# GENERAL ELECTRIC

SUBJECT: IN THE MATTER OF 238 NUCLEAR ISLAND  
GENERAL ELECTRIC STANDARD SAFETY ANALYSIS REPORT  
(GESSAR II) DOCKET NO. STN 50-447

REVISED DRAFT RESPONSES

Figure 6.2-7. Long-Term Drywell Temperature Response Following a Main Steamline or Recirculation Line Break

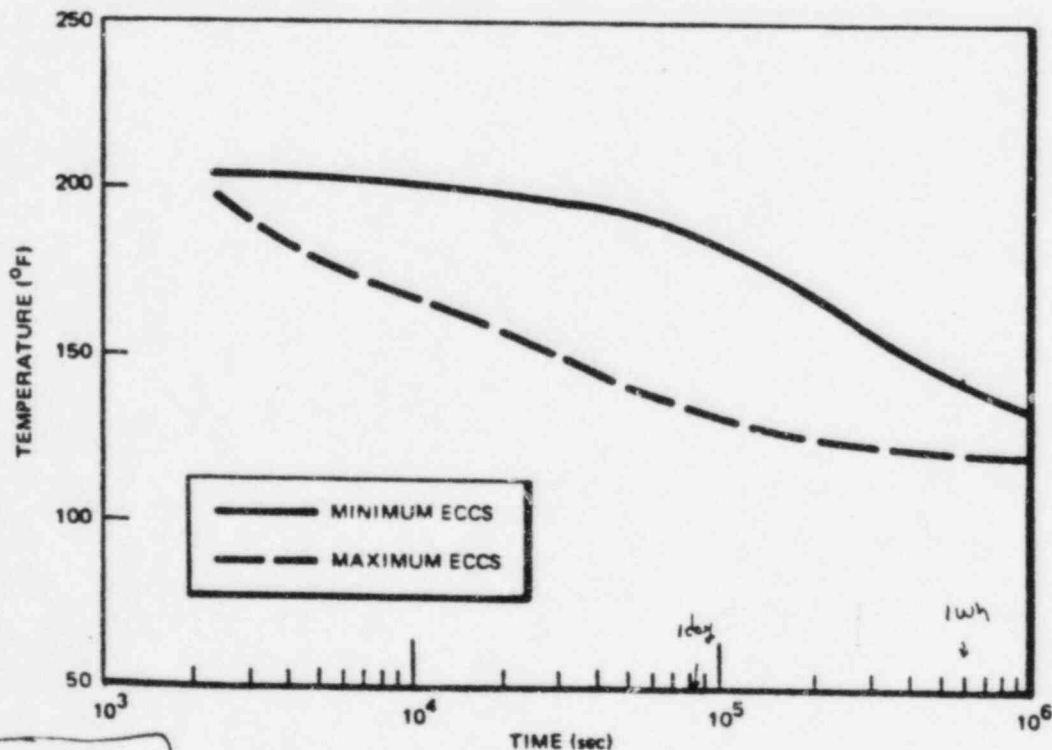
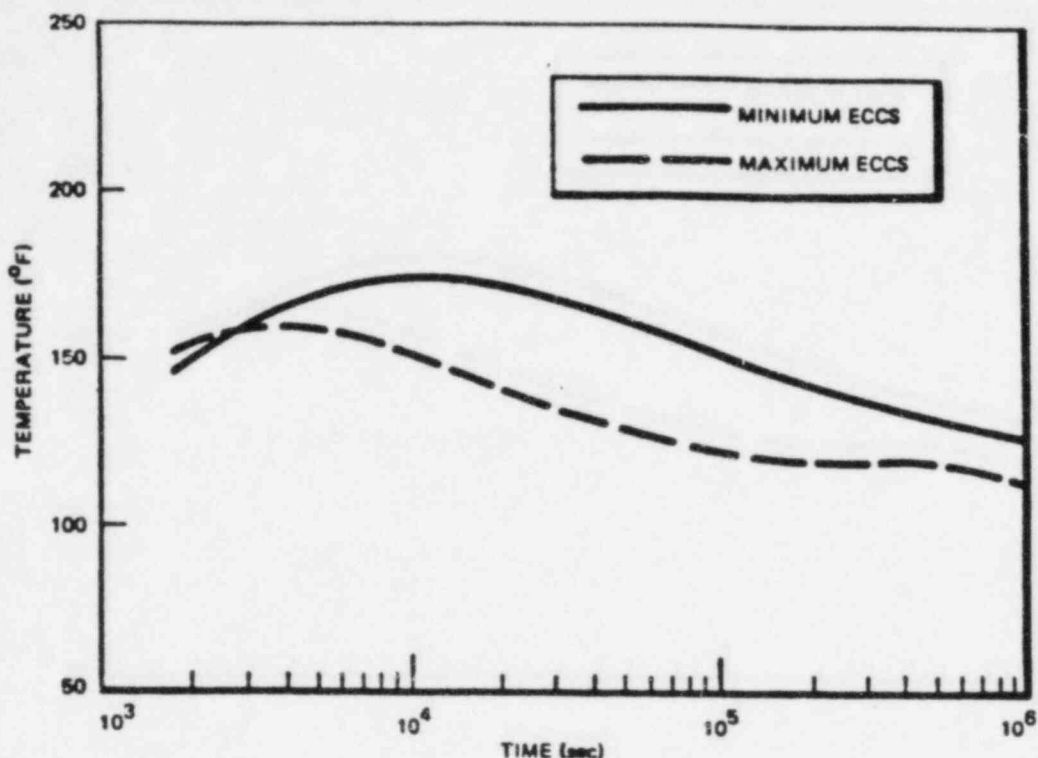
The sprays that are used to control temperature in a BWR containment come from the suppression pool and consist of essentially neutral water (pH 6.5 to 7.5). There are no sources of chemicals in the containment to appreciably change this pH. The environmental temperature profile expected is described in Figures 6.2-7 and 6.2-8 of GESSAR II.

Figure 1  
Mathematical model for  
the annular concrete

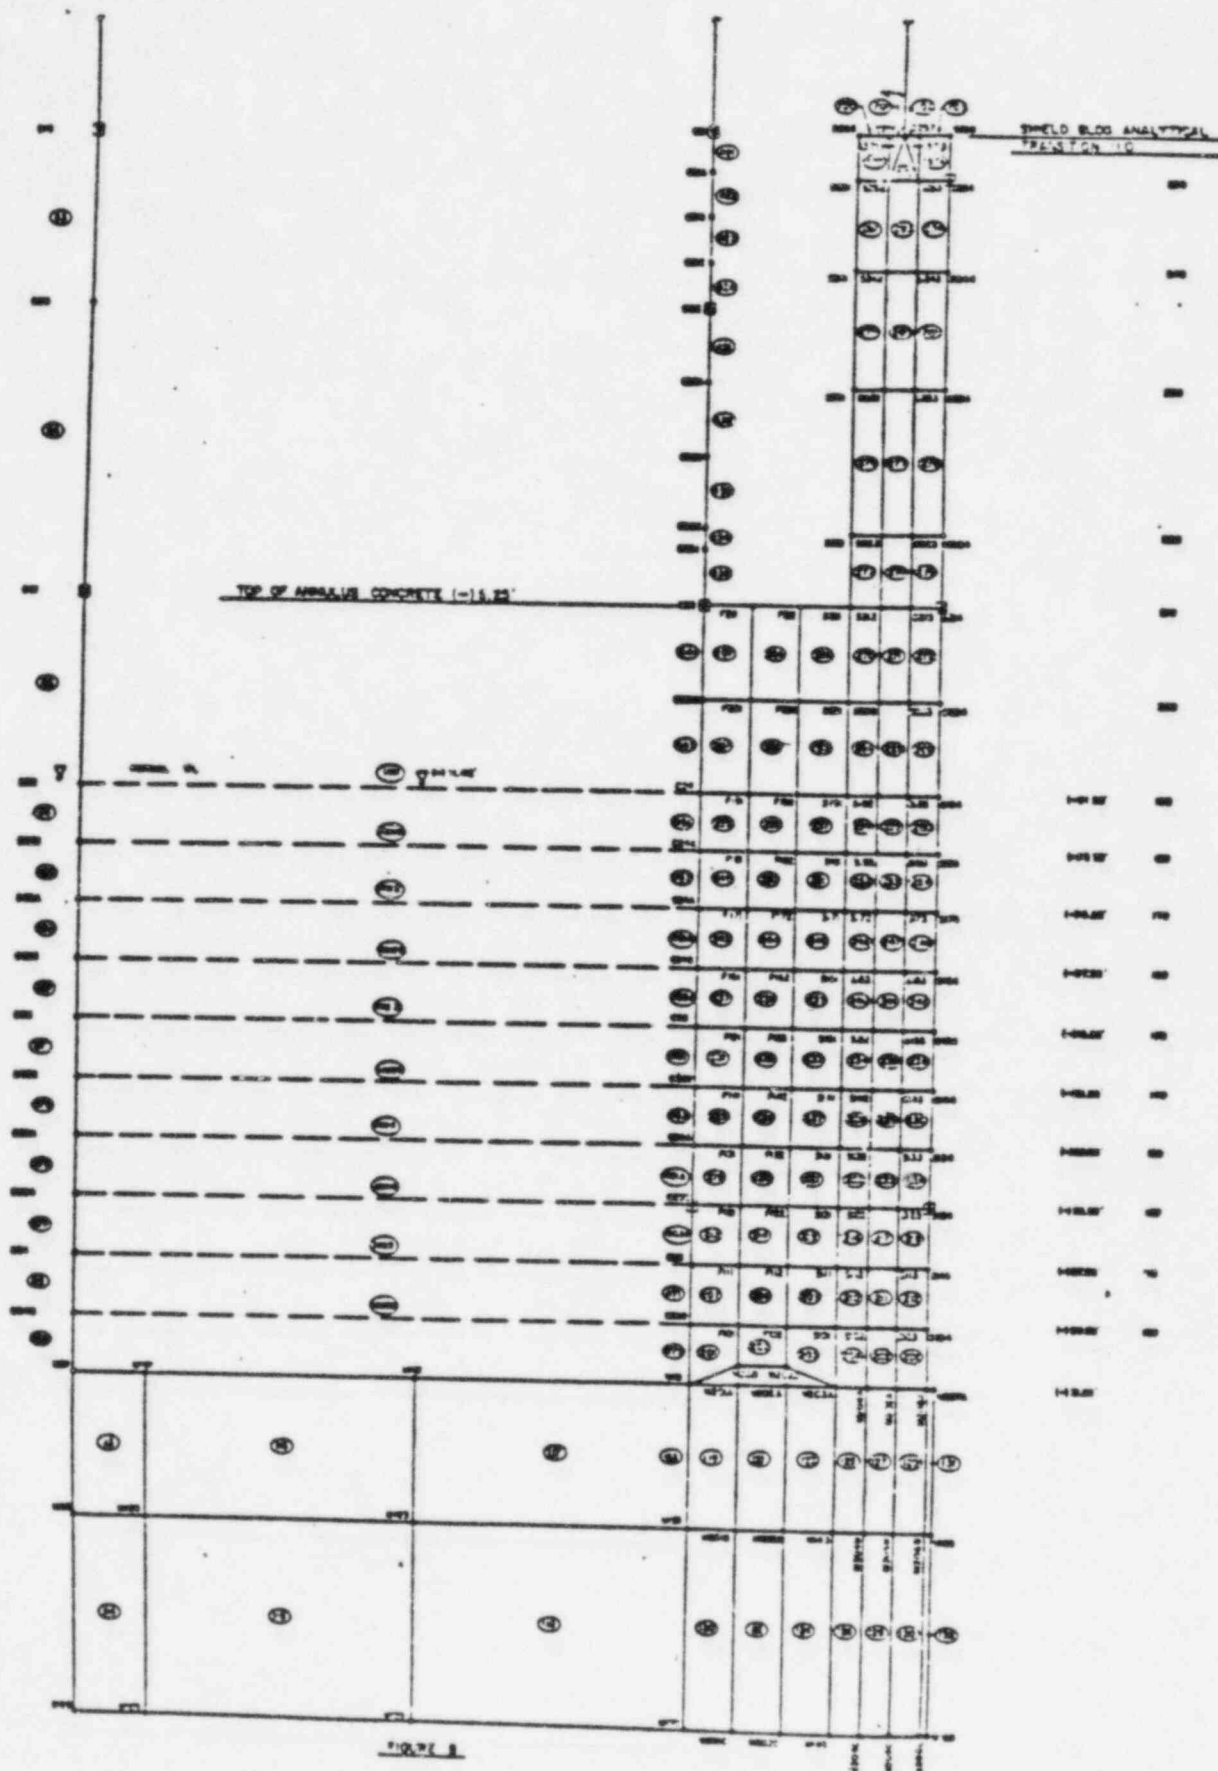
At the time of this review, Appendix 3H which describes the effect of the concrete between the containment and the shield building on the seismic analysis, is not available. Indicate when this appendix will be provided. This information should be made available prior to the forthcoming structural audit in December 1982.

The mathematical model originally used for the analysis to develop the design loads and building responses did not include the concrete added to the region between the containment and the Shield Building below elevation (-) 5 ft 3 in.

For this analysis, <sup>(See figure attached)</sup> solid elements were added to represent the annular concrete. The rest of the model is similar to that used previously, (See Figure -1). The computer program for axisymmetric structures (AXIS) was used in the analysis.

Fig. 3.12-1  
RPV RESPONSE SPECTRA  
HORIZONTAL ACCELERATION ONLY  
EI. 54.0 2 PERCENT DAMPING

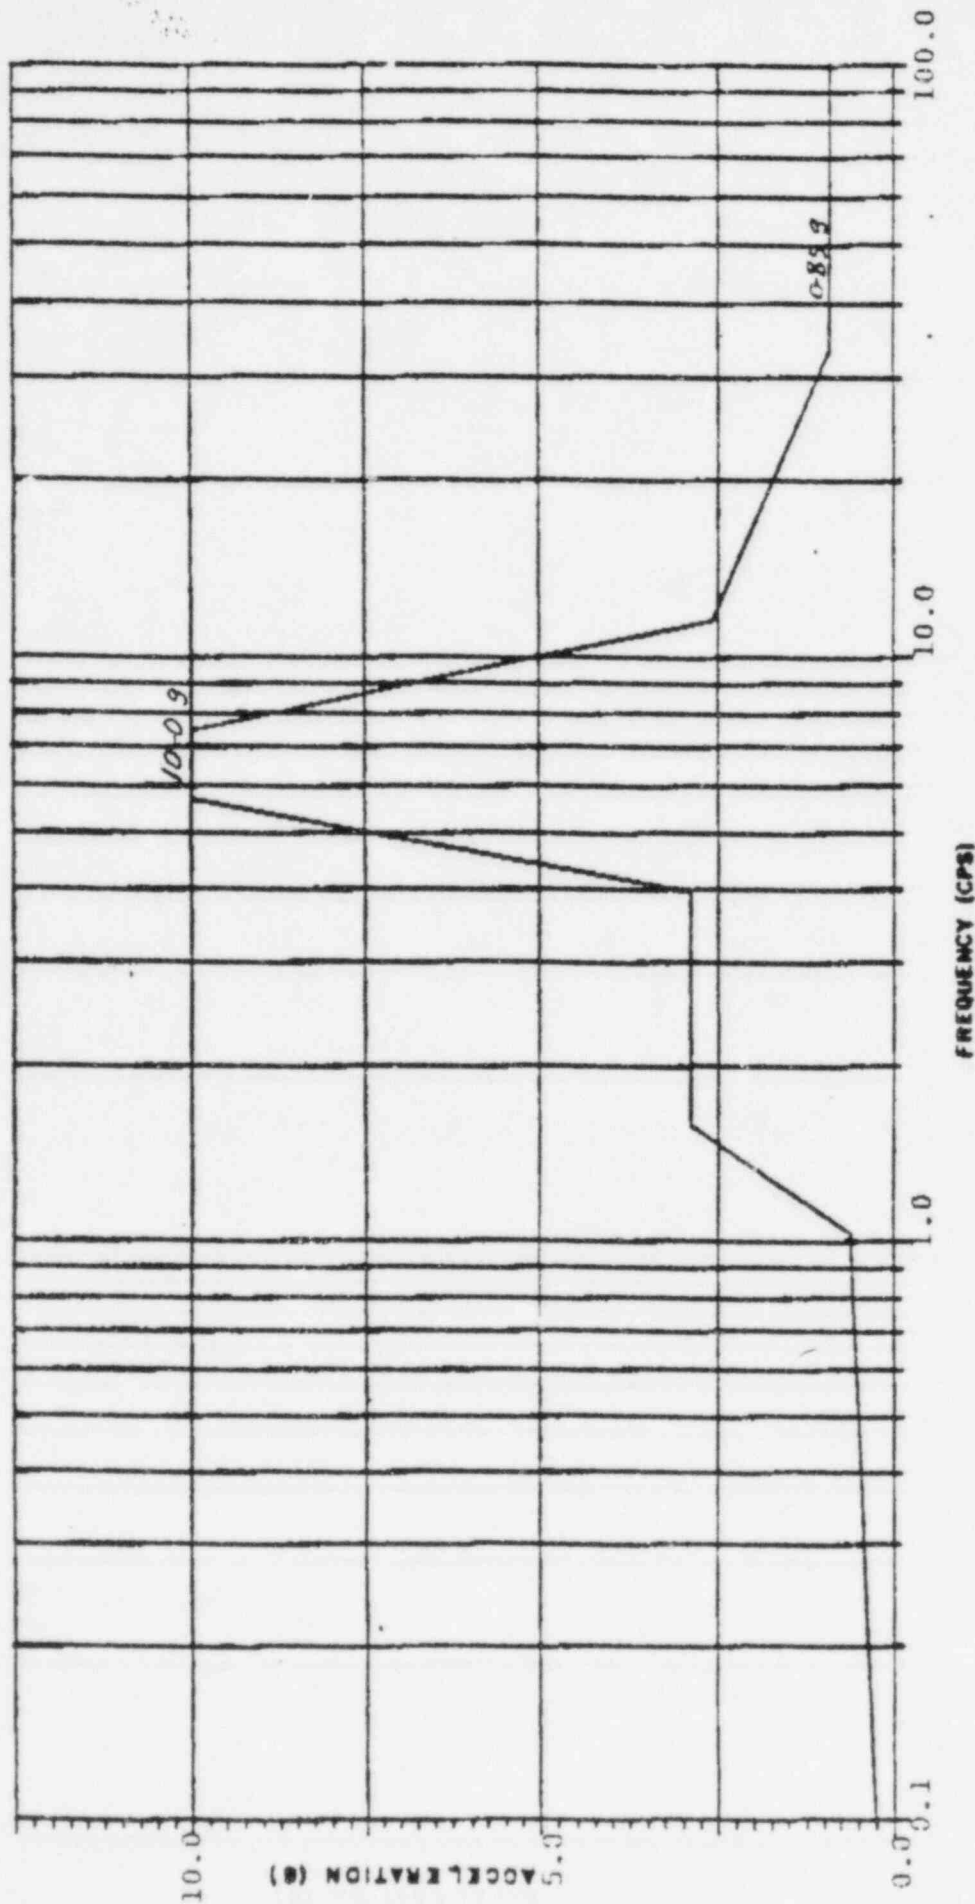
The revised response spectra are listed below  
and are attached

<u>Figure</u>	<u>Title</u>
3.10-1	RPV Floor Response Spectra Horizontal Acceleration OBE El 54.00, 2 Percent Damping
3.10-3	RPV Floor Response Spectra Horizontal Acceleration OBE El 17.83, 2 Percent Damping
3.10-8	Shield Wall Floor Response Spectra Vertical Acceleration OBE, El 43.00, 2 Percent Damping
3.10-19	Containment Response Spectra Horizontal Acceleration OBE, El 149.00, 2 Percent Damping
3.10-20	Containment Response Spectra Vertical Acceleration OBE, El 149.00, 2 Percent Damping
3.10-21	Containment Response Spectra Horizontal Acceleration OBE, El 110.83, 2 Percent Damping
3.10-23	Containment Response Spectra Horizontal Acceleration OBE, El 93.20, 2 Percent Damping
3.10-29	Shield Building Response Spectra Horizontal Acceleration OBE, El 115.90, 2 Percent Damping
